14TH

& REPUBLICAN

**2nd EARLY DESIGN GUIDANCE
DPD #3012837
March 21st, 2012**

DPD PROJECT NUMBER: 3012837

OLD PREFERRED SCHEME

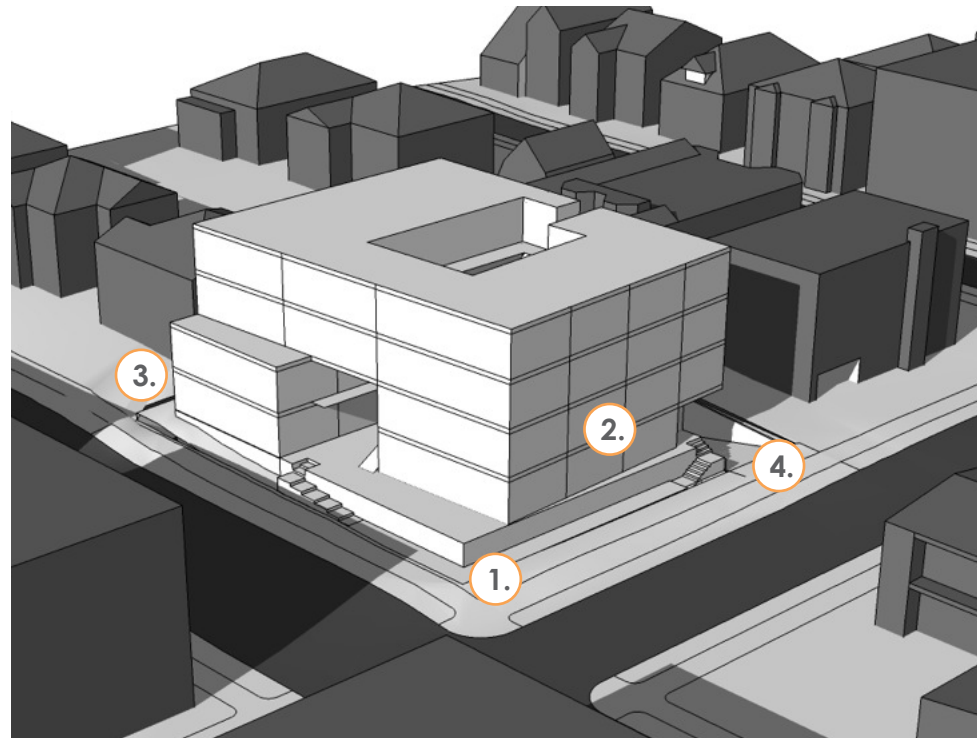
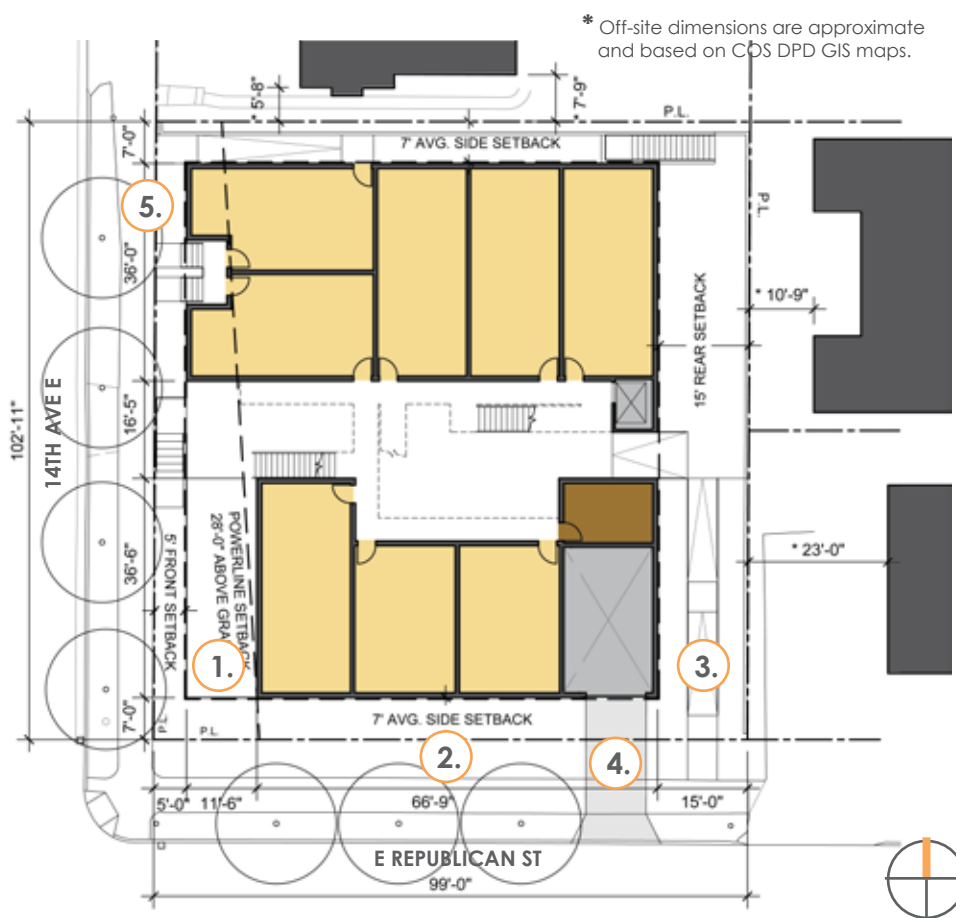
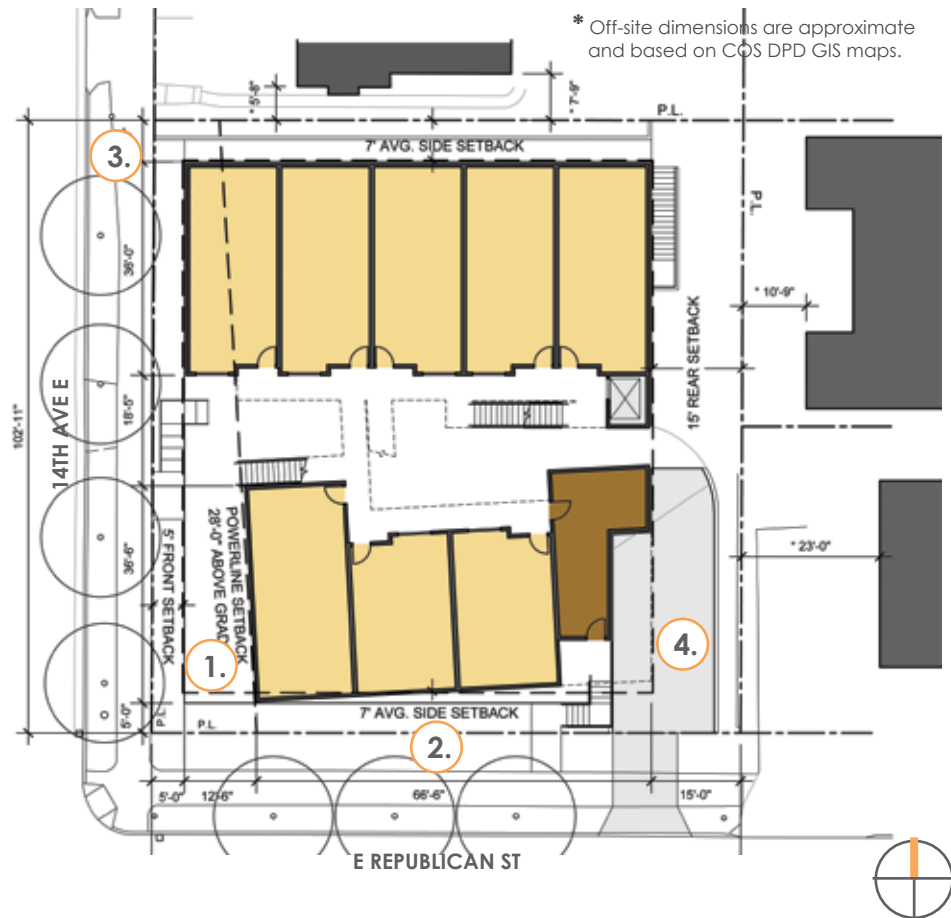
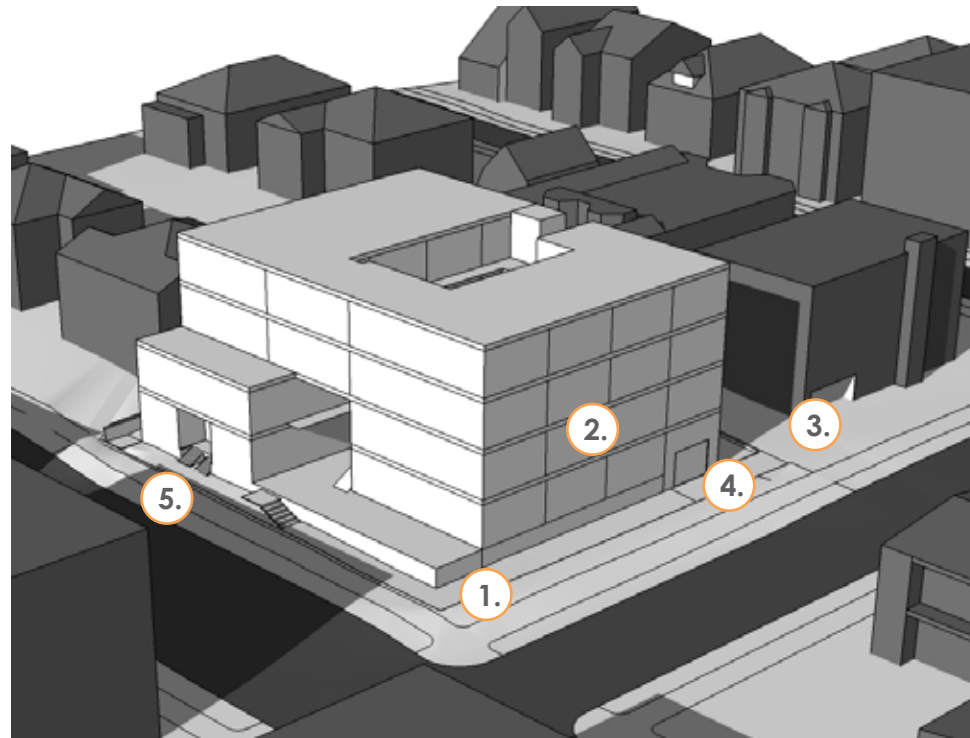
PRIMARY CHANGES TO PREFERRED SCHEME:

- 1. BUILDING PLINTH:**
The garage plinth has been lowered by 1'.
- 2. SOUTH & WEST FACADE**
The South and West facades have been rotated to be orthogonal with the street grid.
- 3. ACCESSIBLE BUILDING ENTRY**
The accessible building access ramp has been co-located with the Republican Street entrance.
- 4. VEHICULAR ACCESS**
The garage access has been relocated to be directly off the street, eliminating the building cantilever.
- 5. STOOP ENTRIES**
Individual stoop entries have been added to engage 14th Avenue to the north.

LANDSCAPE PLAN

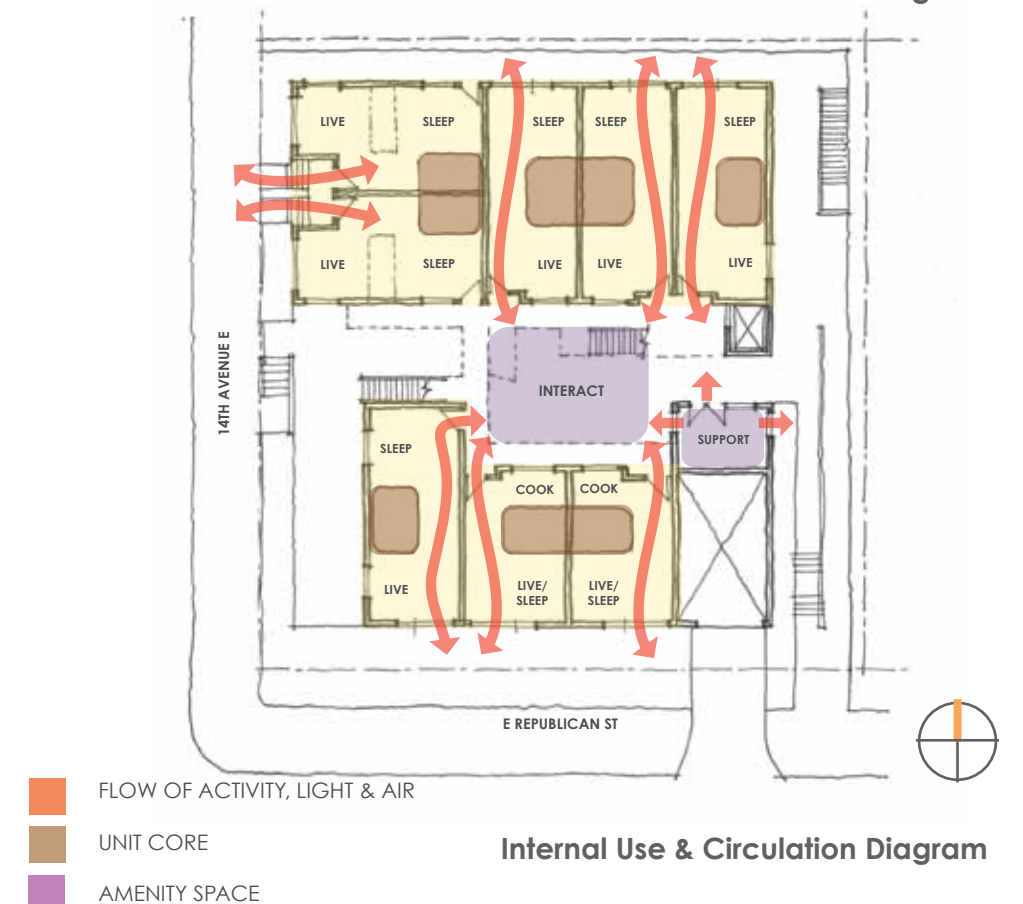
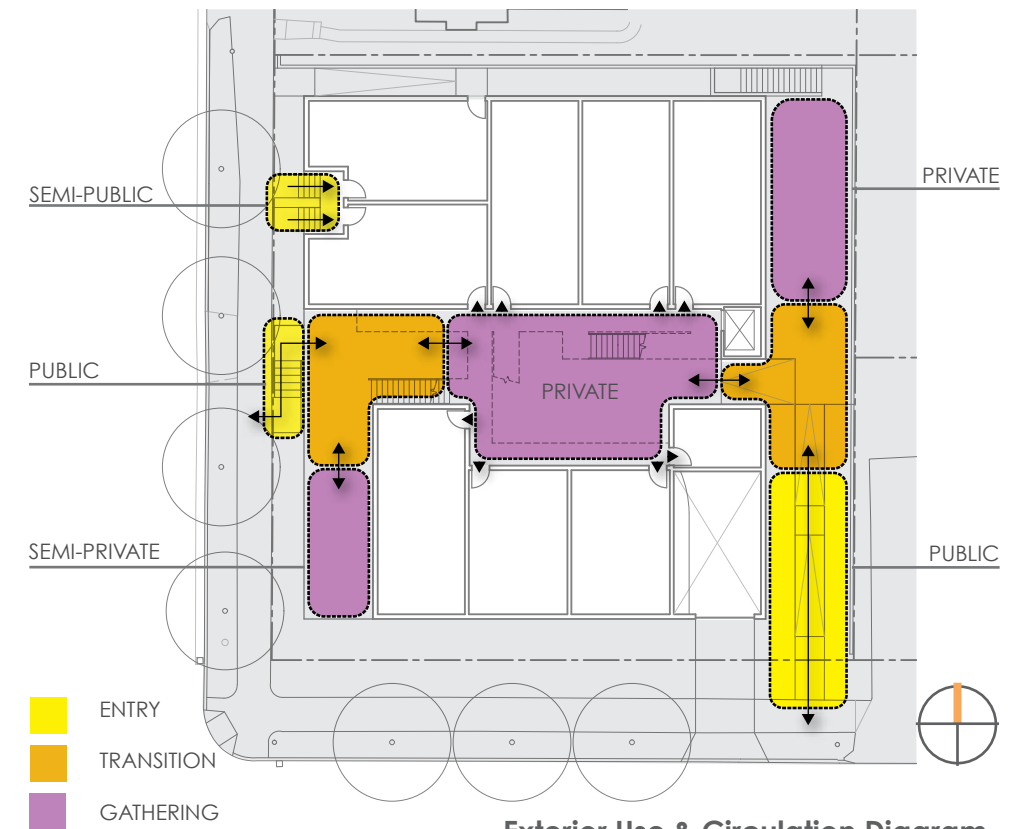
The Board noted the Capitol Hill supplemental guidelines, which are supportive of substantial courtyard-style open space, and asked the applicant to pay special attention to the activation of the courtyard and how it will relate to the street. (A4, A7)

The Board noted the Capitol Hill guideline addressing set-back on upper floors to provide solar access to the sidewalk and/or neighboring properties and requested new concept schemes, as well as shadow studies for all schemes, addressing these concerns. (A5, A7)

The proposed building design will be centered around a **landscaped courtyard, acting as a central community amenity** to tenants. The individual unit entrances are exterior, allowing living spaces to open out onto the courtyard, facilitating tenant interaction. Access paths to the site lead through a succession from public through semi-public to private spaces, providing a gradual transition from the streetscape.

Locating **access points, both along 14th and Republican**, will connect the site to both streets. In order to further encourage human activity at streetlevel, ground-floor units will have **stoop entries** directly engaging the street to the north. A setback on the SW corner of the lot will provide a **corner amenity space**, allowing activity to spill from the courtyard to the streetscape. The facade will feature large windows visually connecting the building to the streetscape and units facing the street will have main living spaces located on the street side.

Locating a generous **corner setback and two-story volume along the west property edge will increase access to light** for the pedestrian environment along 14th Avenue, as well as neighboring properties to the north. (Refer to APPENDIX A for shadow studies.)

Massing Study

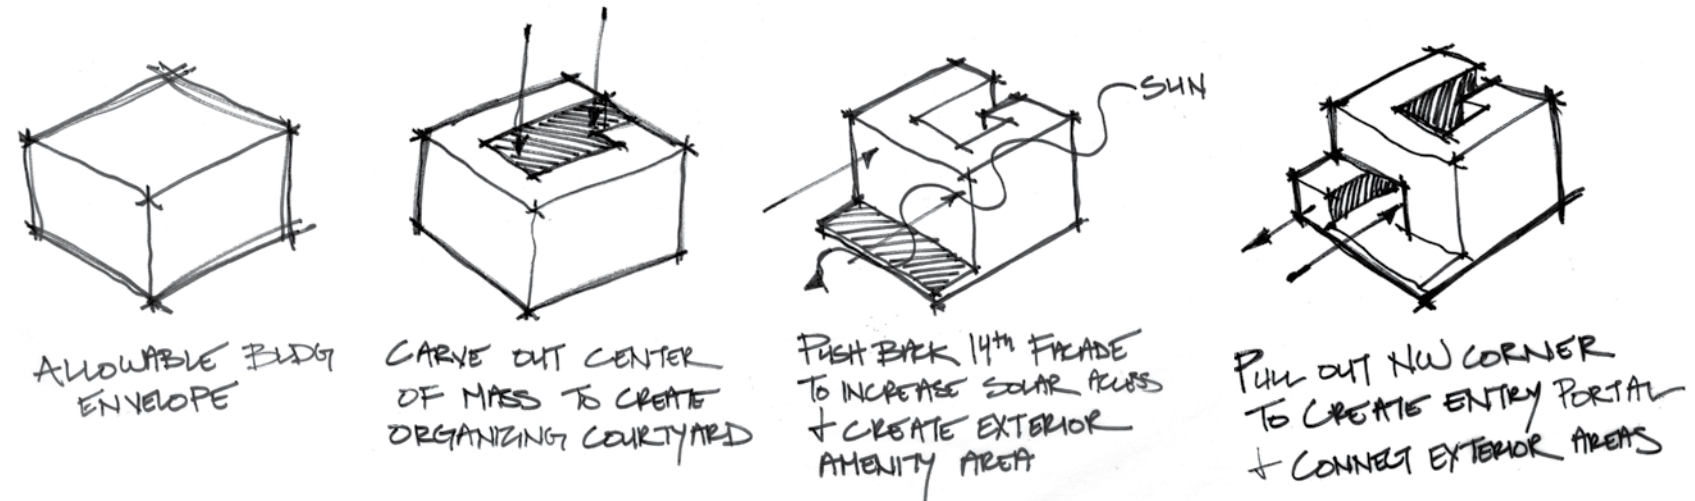
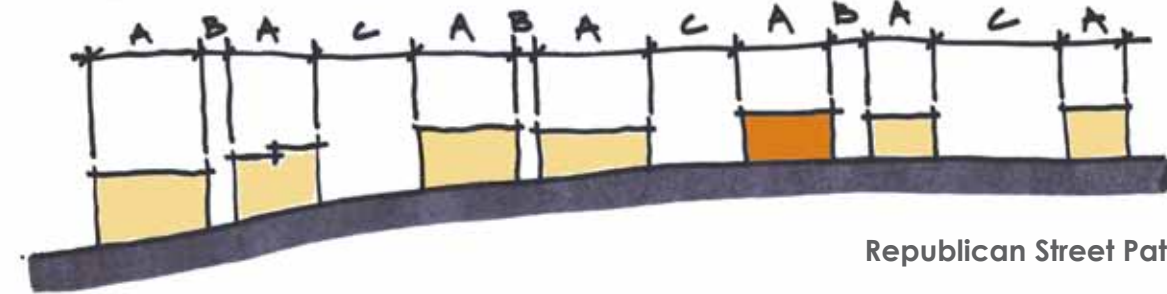
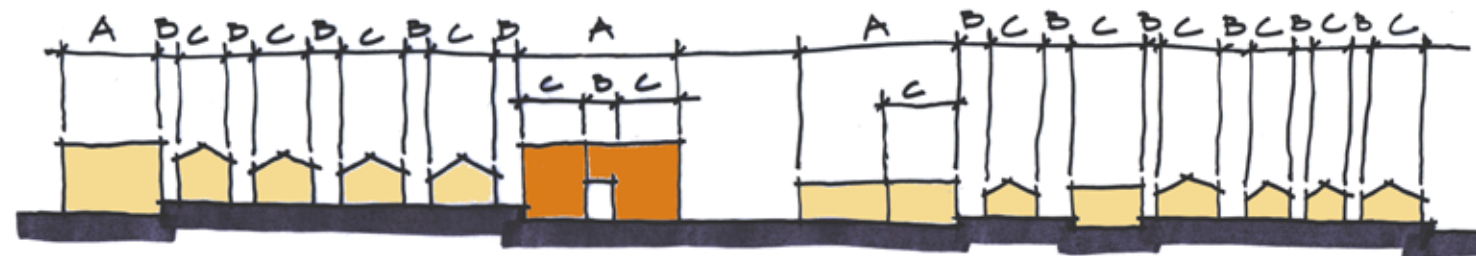
The Board asked the applicant to better address the neighborhood context and to consider techniques to reduce the perceived building scale, such as a step back in height near neighboring properties. The Board was specifically concerned about the parking plinth adding unnecessary height and felt that the neighborhood pattern has a closer relationship to grade. The Board noted that features, such as a driveway cantilever and the courtyard portal, augment the buildings scale. The board would like the applicant to pay close attention to the grand entrance to the courtyard and how it can promote a greater sense of intimacy.

The proposed building design will feature **major modulation along 14th Ave E.**, visually dividing the facade into three volumes, responding to the shorter facades along the north-south corridor. A two-story volume with individual stoop-entries will help to reduce the perceived mass of the building and create a pedestrian friendly row-house feel towards the northwest corner.

The **courtyard portal creates a well defined entry area** and marks the transition from public to private.

Along Republican, the proposed design will hold the property edge, consistent with the uninterrupted facades of existing multifamily buildings prevalent along the east-west corridor.

A large setback to the east will provide a buffer zone to the neighboring properties.

The proposed design shows the **plinth lowered to a height of 4' along Republican sloping back to 2' along 14th Ave. E.** The raised exterior amenity area is consistent with the existing neighborhood pattern and will create a distinction from public to private as it pertains to ground-level amenity space, as well as enhance tenant privacy and security. This raised ground-level space provides a protected exterior amenity area, as intended by the new Lowrise code revisions.

The building's **garage access will be directly off the street**, eliminating the cantilever and allowing for a landscaped entrance path to the courtyard along the east setback. The garage entry off Republican fits the pattern of existing buildings in the neighborhood.

14th AVENUE ENTRY STUDY

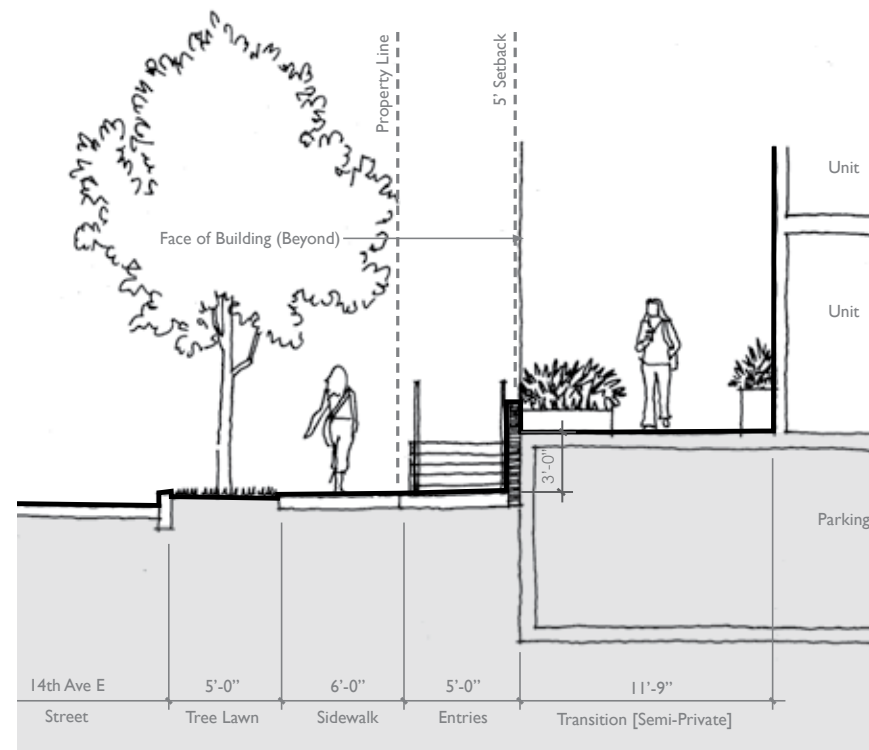
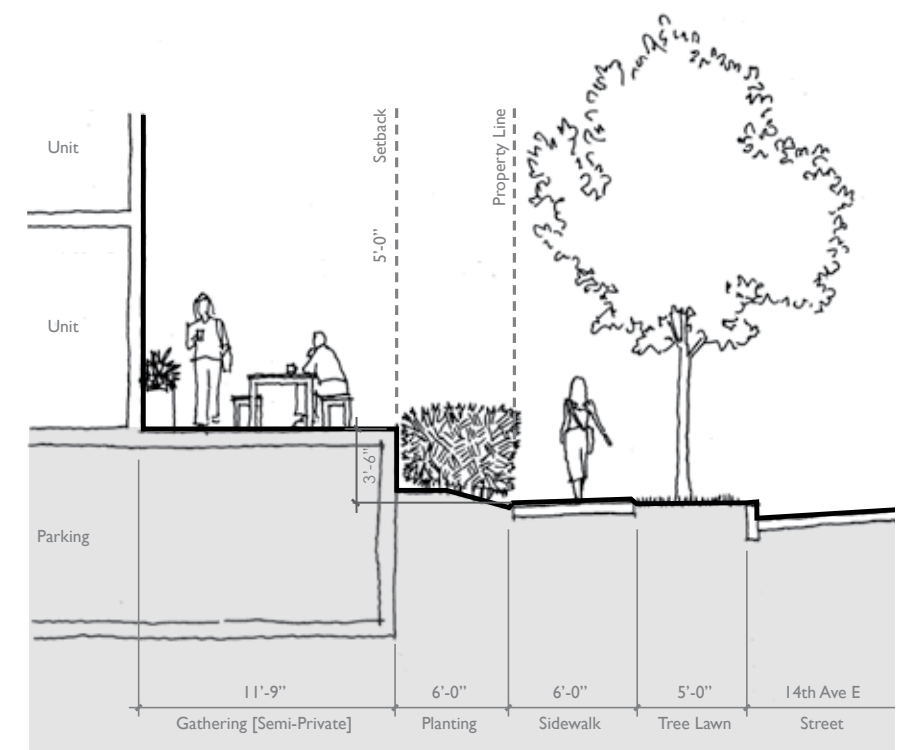
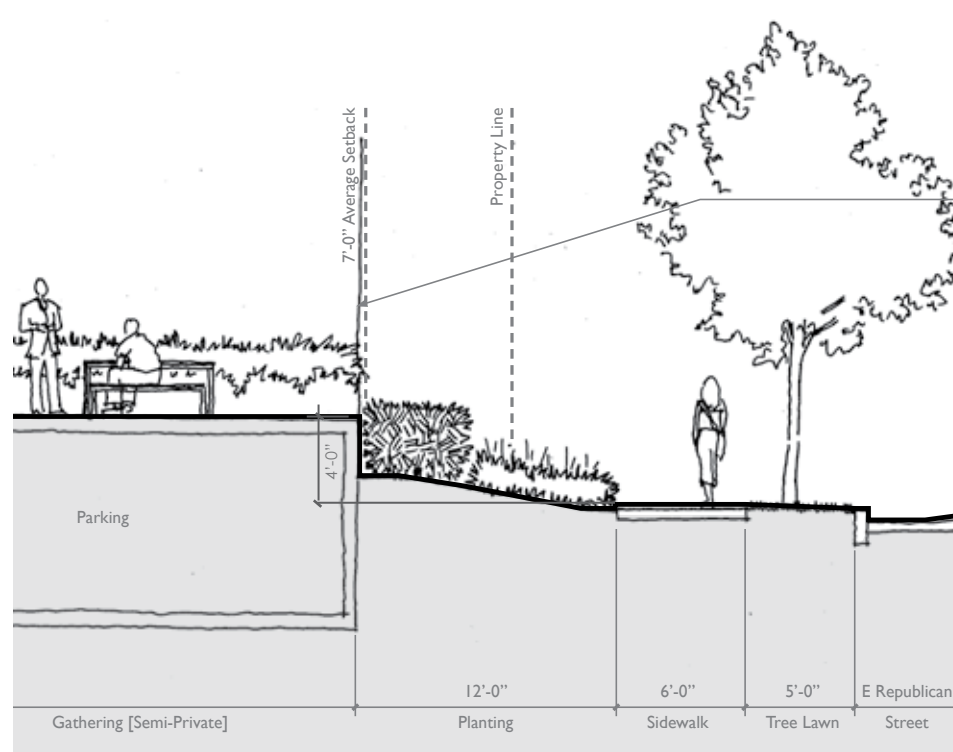
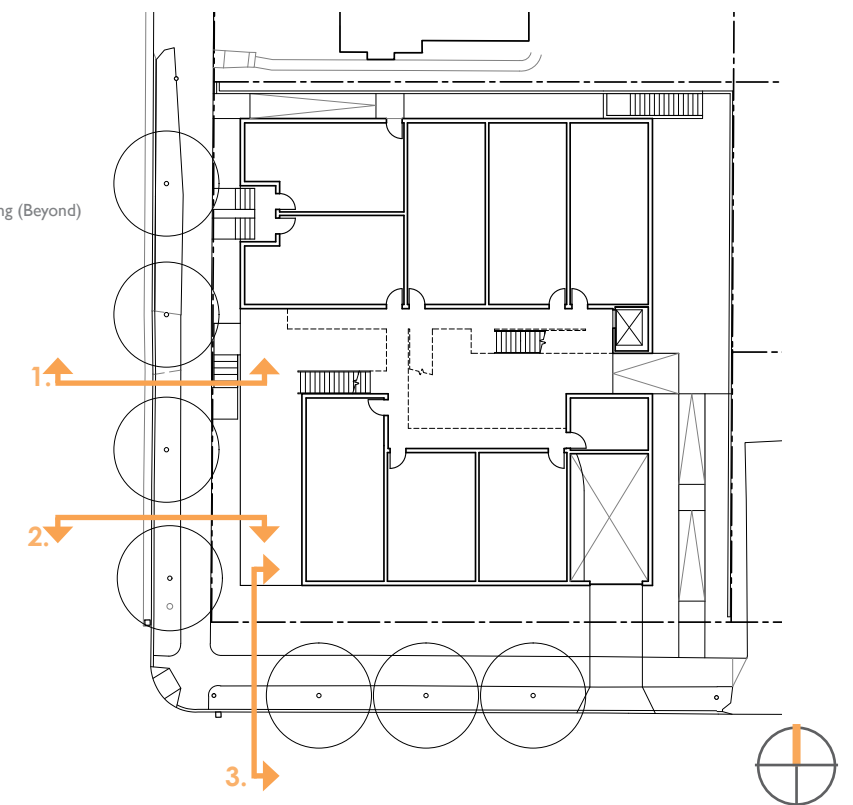
The Board noted that the courtyard, with exterior unit entries could function like a mews, but questioned the placement of the lobby at the east end. The Board asked the applicant to relocate the accessible entry path from the proposed location along the north edge, to provide a more direct access route to the courtyard. (D1)

The Board felt that the site grade, along with the garage plinth, places the building too high above sidewalk grade and requested the building garage plinth to be lowered to create a better relationship between building and streetscape. (D3)

The Board also noted that all pathways should be well-lit. (D7)

The entry along 14th Ave will feature a gradual transition from the sidewalk to the elevated courtyard, with an emphasis on **creating a procession through lively exterior amenity spaces**. Residential stoop entries and large windows will further connect the building to the street.

The design will feature a **prominent entry along Republican**, which will be co-located with the accessible entry ramp, providing direct access to the courtyard and elevator.

The **garage plinth has been lowered** to a height of 4' along Republican sloping back to 2' at the NW corner of the site along 14th Avenue. The plinth is an opportunity to create an attractive mix of greenscape and hardscape elements that will add visual interest to the streetscape, yet be at a proper height that will enhance privacy and security for ground level units, as well as exterior amenity areas.

Going forward, the design team will pay special attention to the landscape and lighting treatment of these transitional spaces.
